Monticello Nuclear Generating Plant
2807 W County Rd 75
Monticello, MN 55362

License Amendment Request for Fuel Storage Changes
Supplement to Propose a Spent Fuel Pool
Boral Monitoring Program Technical Specification (TAC ME9893)

Evaluation of the Proposed Change
License Amendment Request Supplement
to Propose a Spent Fuel Pool Boron Monitoring Program
Technical Specification

Marked-Up Technical Specification Pages

**5.5-12
Insert (new Section 5.5.14)**

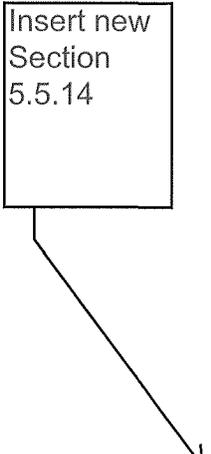
Insert new
Section
5.5.14

5.5.14 Spent Fuel Pool Boral Monitoring Program

The program provides routine monitoring and actions to ensure that the condition of Boral in the spent fuel pool racks is appropriately monitored to ensure that the Boral neutron attenuation capability described in the criticality safety analysis of USAR Section 10.2.1 is maintained. The program shall include the following:

- a. Periodic physical examination of representative Boral coupons or in situ storage racks at a frequency defined by observed trends or calculated projections of Boral degradation.
- b. Neutron attenuation testing of a representative Boral coupon or in situ storage rack shall be performed prior to December 31, 2015, and thereafter at a frequency of not more than 10 years, or more frequently based on observed trends or calculated projections of Boral degradation.
- c. Description of appropriate corrective actions for discovery of non-conforming Boral.
